Figure 1 shows the center four grids of (a) Original view and (b) Extracted view.

Figure 1 Center four grids

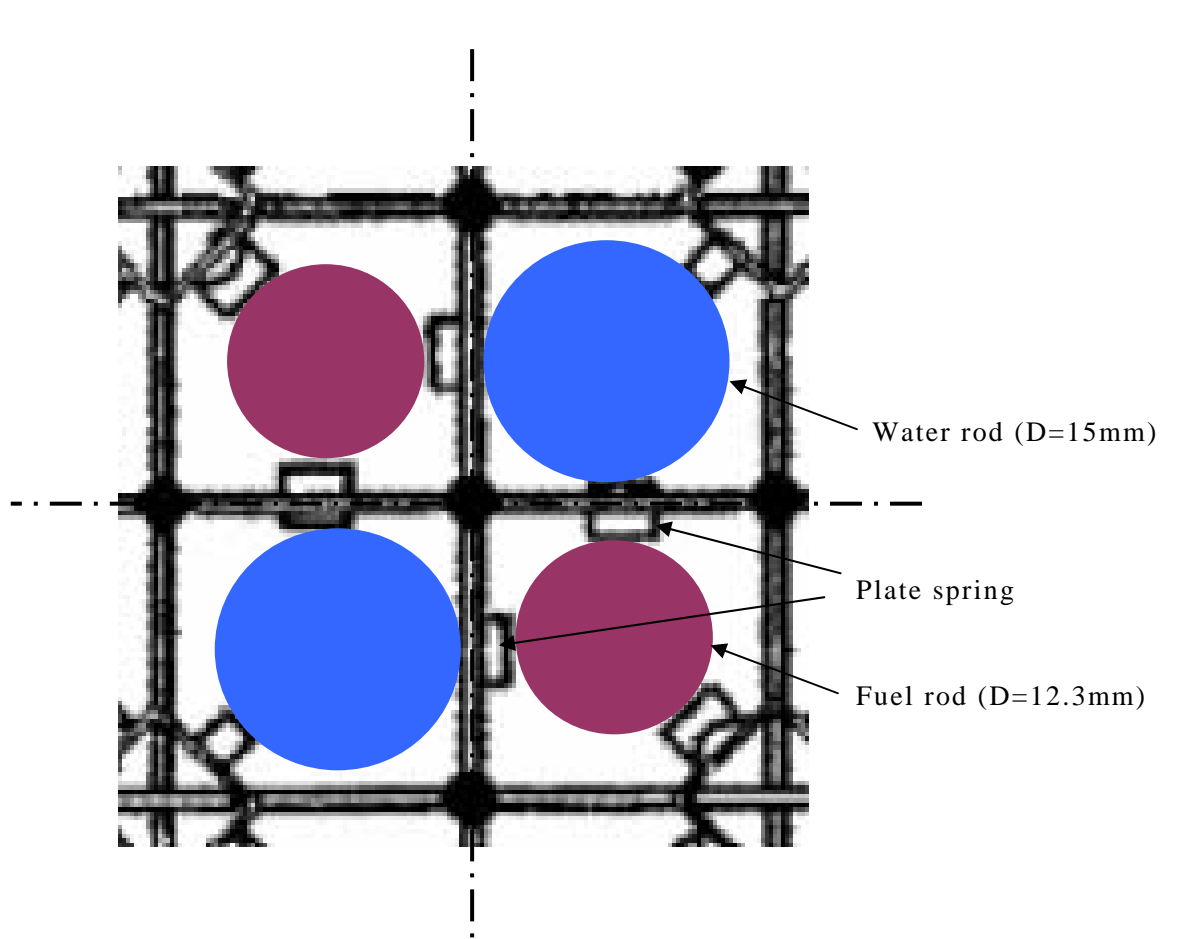
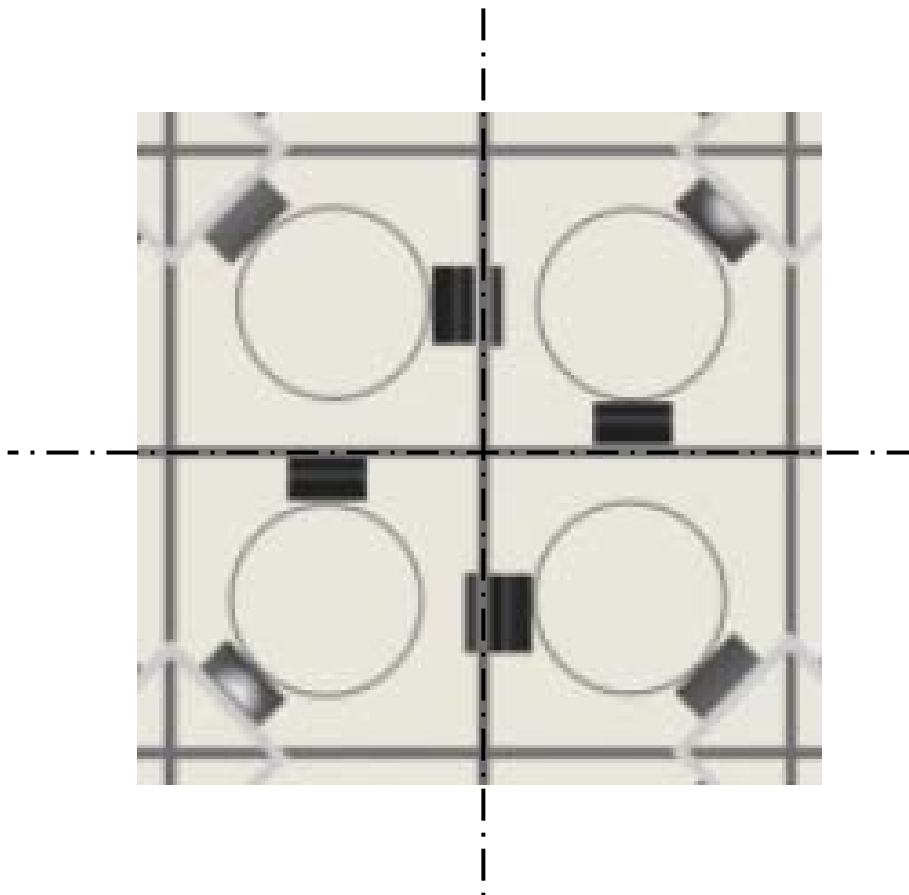
There is a following inconsistency between (a) and (b).

There are two fuel rods and two water rod in these grids. A diameter of fuel rod is 12.3 mm and water rod 15 mm. The grid containing a fuel rod has two plate springs. The grid containing a water rod doesn't have them.

Each four grids have a plate spring.
